## RESPONSES TO CEC DATA REQUESTS (#113-134)

APPLICATION FOR CERTIFICATION (07-AFC-8)

Carrizo Energy Solar Farm  
Carrizo Energy, LLC

Subject: Carrizo Energy Solar Farm (07-AFC-8)  
Applicant's Responses to CEC Data Requests 113-134  
URS Project No. 27658060.01800

**PLANNED LINKAGES FIGURE FROM USFWS  
RECOVERY PLAN (PAGE 225)**

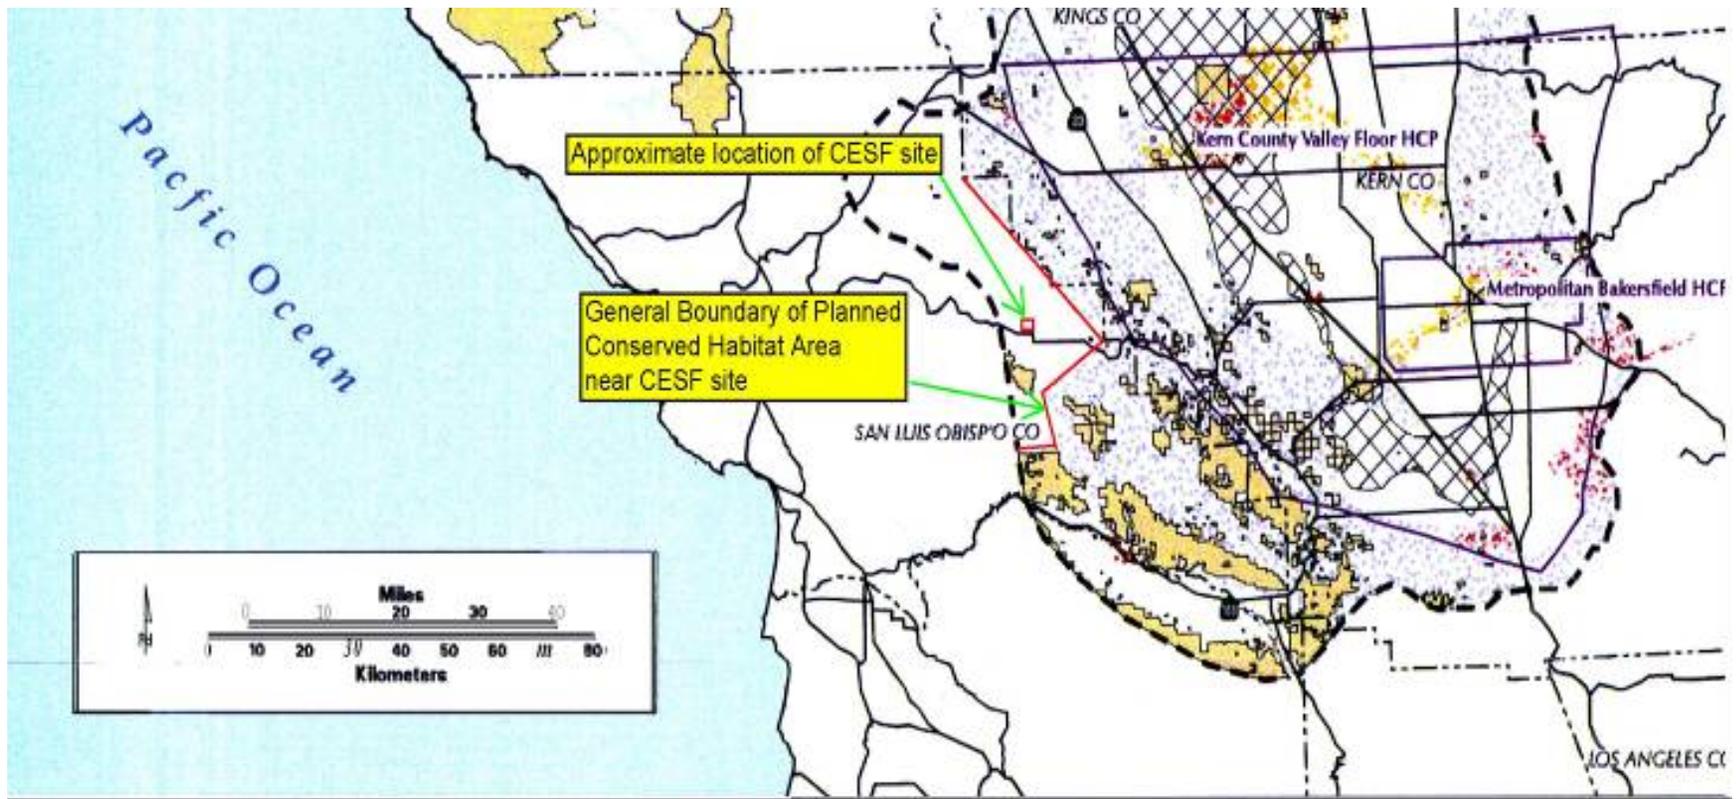
**Data Request 113:** Establish a GIS database of existing land uses, habitat types, tule elk calving areas, and movement corridors of the focal animal species in the Carrizo Plains (San Joaquin kit fox, pronghorn, and tule elk);

**Response:** SJKF do not have “corridors” per se. They are a territorial species. California Valley is used by SJKF; however, it was not identified in the Recovery Plan for Upland Species of the San Joaquin Valley (USFWS 1998) as a corridor to be maintained (see response to background information, below, and Figure 1). The majority of the California Valley is open and allows for unconstrained wildlife movement. The CESF site is not in an overly constraining location for any of the three species of concern. CDFG data indicate that there are three Highway crossing segments with the one east of the CESF site used by both elk and pronghorn (see Figure 2).

In addition, in reference to the Background information provided by CEC for this Data Request, please note the following: CESF is located in California Valley northeast of the Carrizo Plain National Monument. According to the USFWS Recovery Plan for Upland Species of the San Joaquin Valley, and Figure 1 (attached), the CESF site is not located within: 1) An area along the valley's edges within which a contiguous band of natural lands and wildlife-compatible farmlands should be maintained, 2) Proposed specialty reserve areas, or 3) Proposed areas where connectivity and linkages should be maintained. During radio telemetry surveys, Tule elk were not recorded utilizing the CESF project site, and the GPS/GIS data shows the travel corridor of Tule elk does not cross the CESF project site. Instead they follow a travel corridor further east and north of the site. CDFG data indicate that there are three Highway crossing segments with the one furthest east of the CESF site used by both elk and pronghorn (see Figure 2).
